ICC A117.1 Comments on 1st Draft

Proposal list to the 2017 A117.1 for the 2023 edition –
9-12-2024
Chapter 6

CHAPTER 6 PLUMBING ELEMENTS AND FACILITIES

FIGURE 607.3
CLEARANCE FOR BATHTUBS CONTROLS

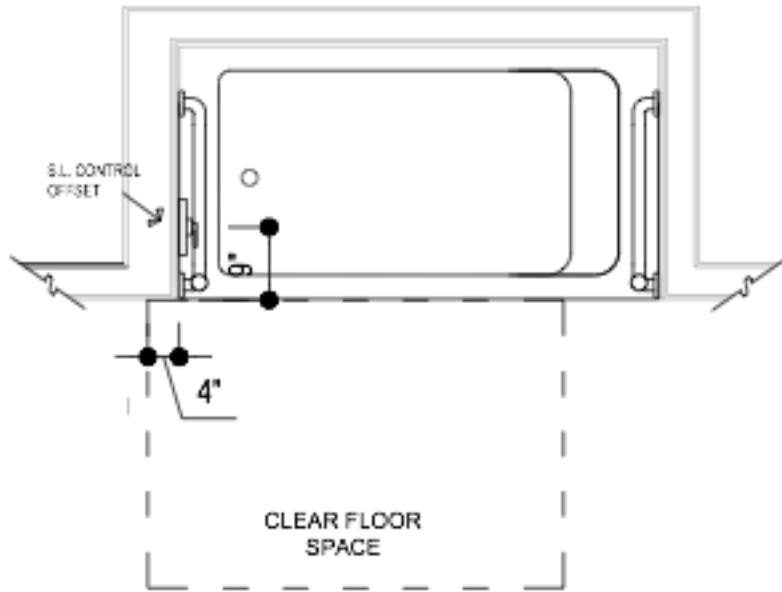
Note: The wall in the Figures 607.2(A) and 607.2(B) would be jogged to indicate the additional 4 inch toe clearance in the new Figure 607.3. The committee will need to decide if Figures 607.2(A) and 607.2 (B) should be revised to show the control clearance with the transfer clearance or if the control clearance should be in a separate Figure 607.3. The figure submitted indicates the transfer clearance moving forward, not an addition 4 inch control clearance as the text indicates.

607.3 Control Clearance. The clear floor space for toe clearance at the controls shall extend 4 inches (100 mm) minimum beyond the control end wall.

FIGURE 607.3
CLEARANCE FOR BATHTUBS CONTROLS

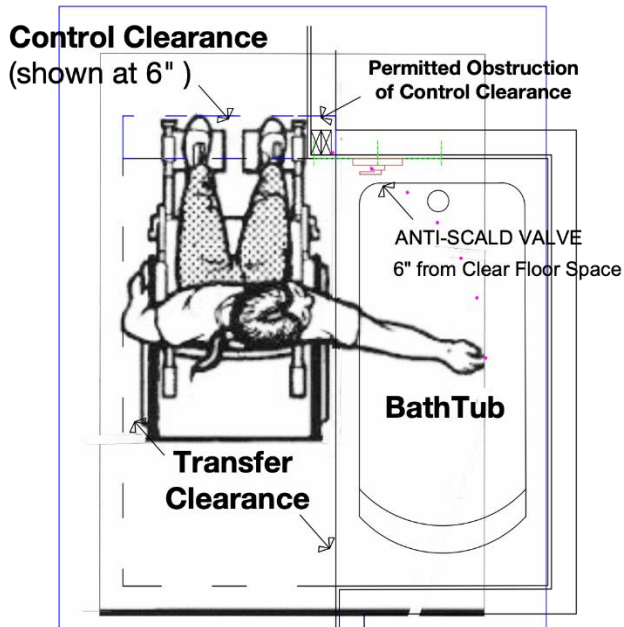
607.3 Control Clearance. The clear floor space for toe clearance complying with Section 306.2 at the controls shall extend 6 inches (152 mm) minimum beyond the control end wall. An obstruction by the control wall of 4 inches (102 mm) maximum shall be permitted.

Note: The wall in the Figures 1103.11.2.5.1(A) and 1103.11.2.5.1(B) would be jogged to indicate the additional 6-inch control clearance in the new Figure 607.3

Figure 607.4.2(A) Grab Bars for Bathtubs with Removable In-tub Seats – Elevation
Note – seat would have to move forward in graphic

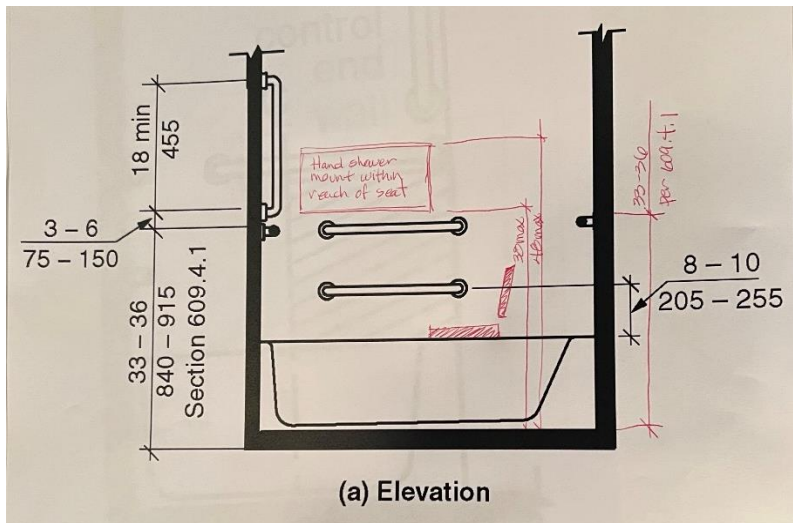
Figure 607.4.2(B) Grab Bars for Bathtubs with Removable In-tub Seats - Plan
Note – seat would have to move forward in graphic

FIGURE 607.2(B)
CLEARANCE FOR BATHTUBS WITH TRANSFER PLATFORMS SEAT AT HEAD END OF TUB

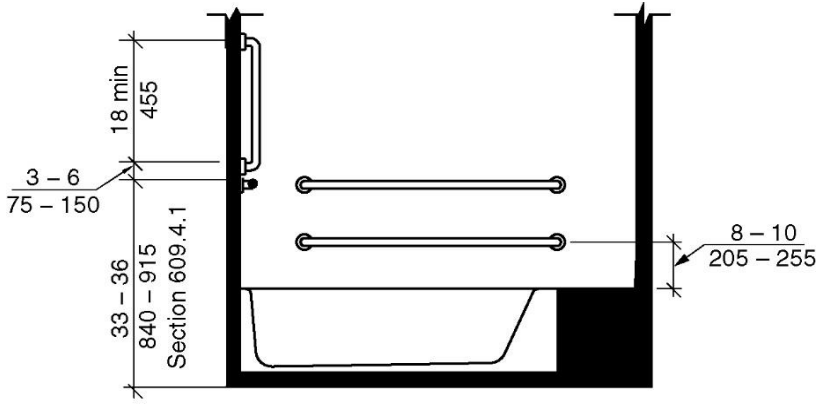
Note: Add removeable seat to drawing

FIGURE 610.2(B) 610.2.2

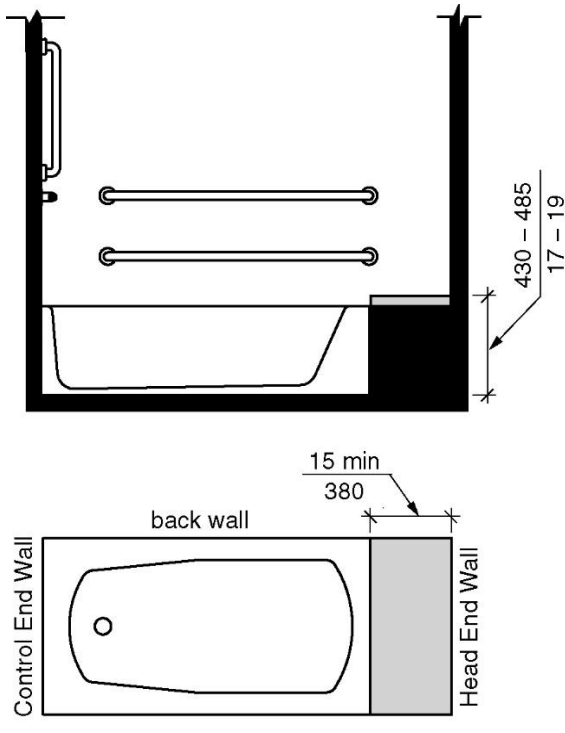
610.2.2 Bathtubs with transfer platforms. ~~Permanent seats~~ Transfer platforms shall be 15 inches (380 mm) minimum in depth and shall extend from the back wall to or beyond the outer edge of the bathtub. ~~Permanent seats~~ Transfer platforms shall be positioned at the head end of the bathtub.

FIGURE 607.4.3(A)
GRAB BARS FOR BATHTUBS WITH FIXED FOLDING IN-TUB SEATS – ELEVATION

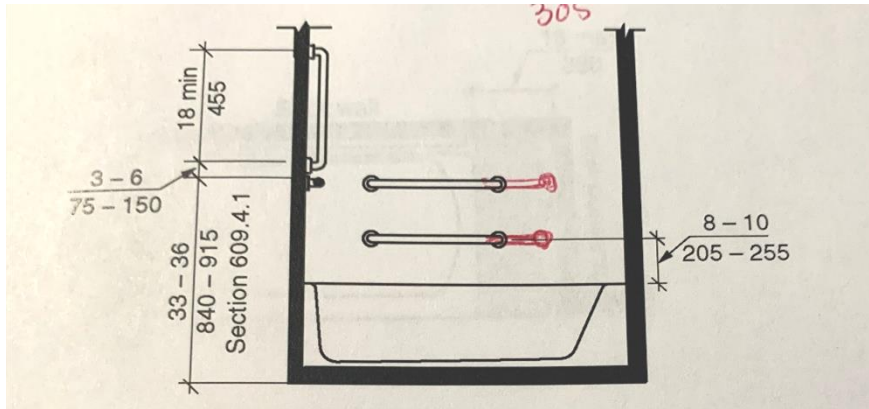
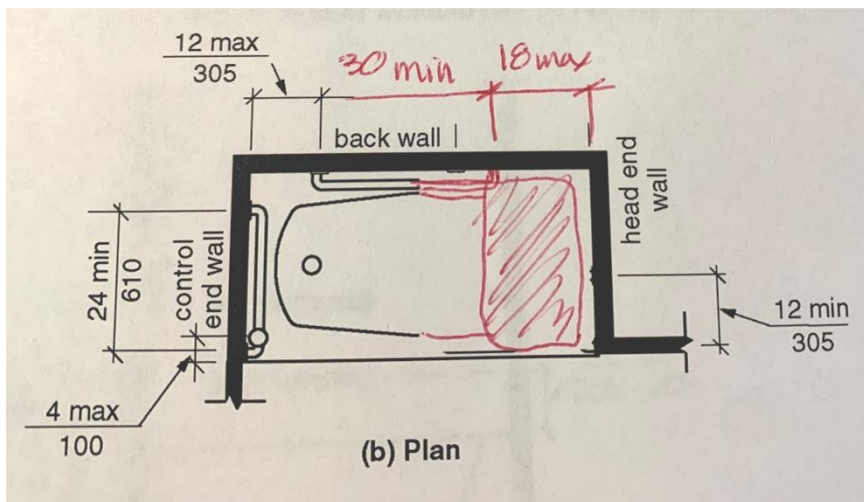
607.4.3.2.2 Vertical grab bar. A vertical grab bar 18 inches (455 mm) minimum in length shall be provided on the control end wall 3 inches (75 mm) minimum and 6 inches (150 mm) maximum above the horizontal grab bar, and 4 inches (100 mm) maximum inward from the front edge of the bathtub.

FIGURE 607.6.2
LOCATION OF MOUNT FOR BATHTUB WITH FOLDING SEAT

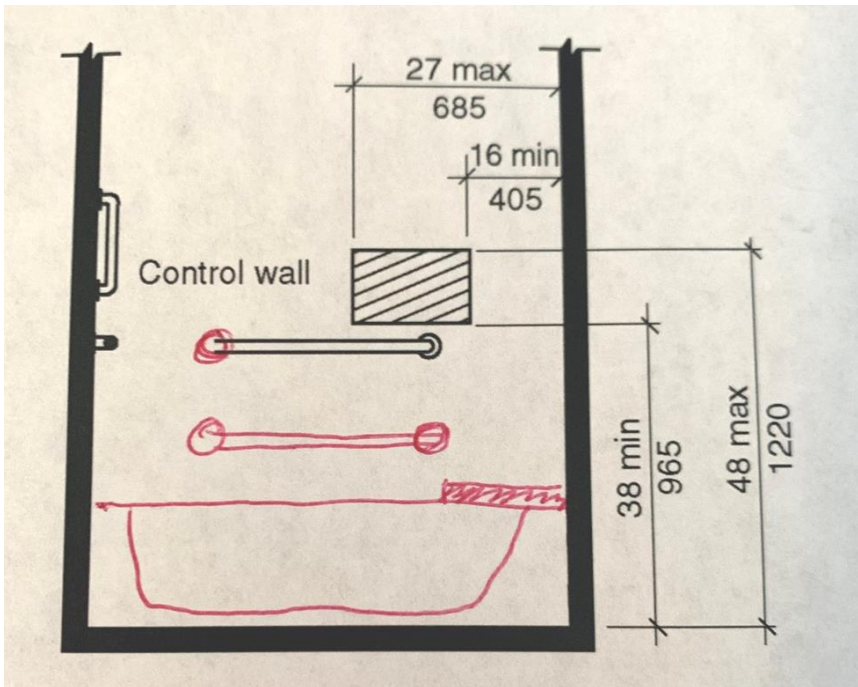
Exception: The mount to hold the hand shower shall be permitted to be located on a vertical bar provided that the mount is adjustable in height and can be located within the area specified for the fixed mount.

FIGURE 610.2.3
BATHTUB SEATS
FOLDING IN-TUB SEAT PROVIDED AT HEAD END OF TUB

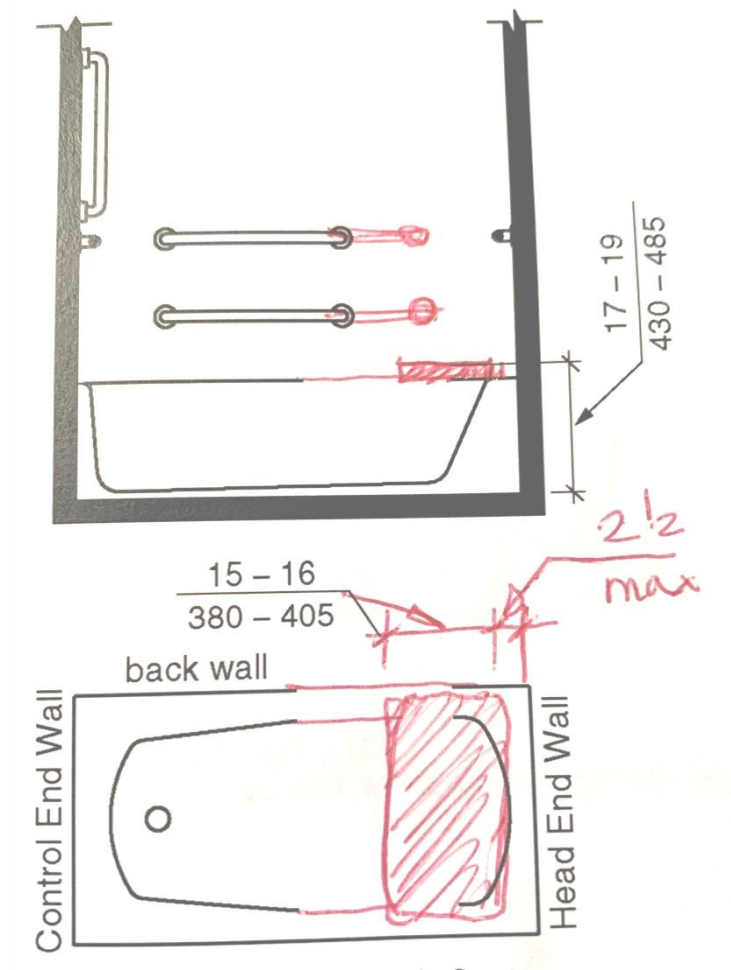
610.2.3 Folding in-tub seats. Folding in-tub seats shall be mounted on the head wall. The rear edge of a seat shall be 2-1/2 inches (64 mm) maximum and the seat shall be 15 inches (380 mm) minimum and 16 inches (405 mm) maximum in depth. The side edge of the seat shall be 1-1/2 inches (38 mm) maximum from the back wall.

FIGURE 608.2.1.3
TRANSFER-TYPE SHOWER COMPARTMENT
CLEARANCES FOR SHOWER CONTROLS

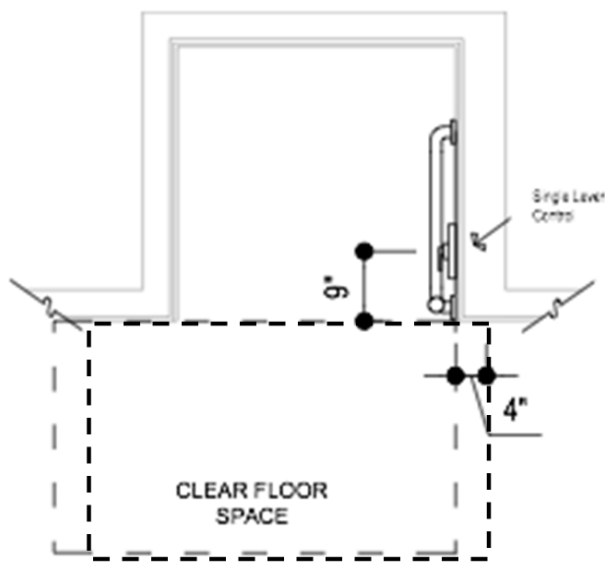
608.2.1.3 Control Clearance. The clear floor space for toe clearance at the controls shall extend 4 inches (100 mm) minimum beyond the control end wall.

FIGURE 608.4.1
TRANSFER-TYPE SHOWER CONTROLS AND
HAND SHOWER LOCATION

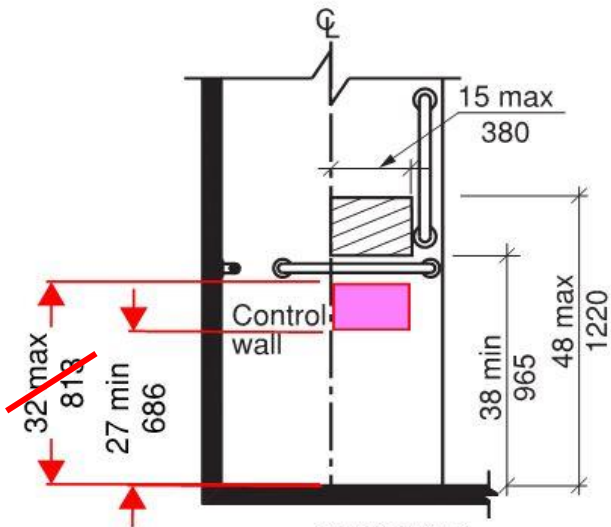
Note: Revise figure to include additional control location.

**FIGURE 609.3
SPACING OF GRAB BARS**

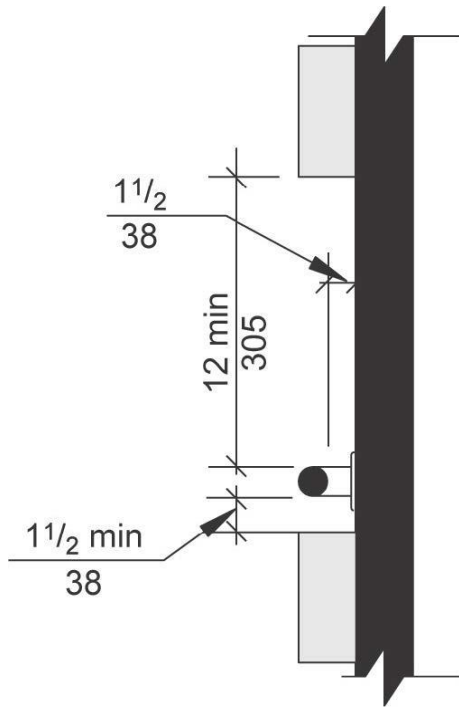
1. The space between the grab bars and shower controls, shower fittings, and other grab bars above the grab bar shall be permitted to be 1 1/2 inches (38 mm) minimum.
2. Recessed dispensers projecting from the wall 1/4 inch (6.4 mm) maximum measured from the face of the dispenser and complying with Section 604.7 shall be permitted within the 12-inch (305 mm) space above and the 1 1/2-inch (38 mm) spaces below and at the ends of the grab bar.
3. Flushing device cover plates and their controls projecting from the wall up to 1 inch (25 mm) maximum shall be permitted to be 1-1/2 inch (38 mm) minimum above the grab bar.
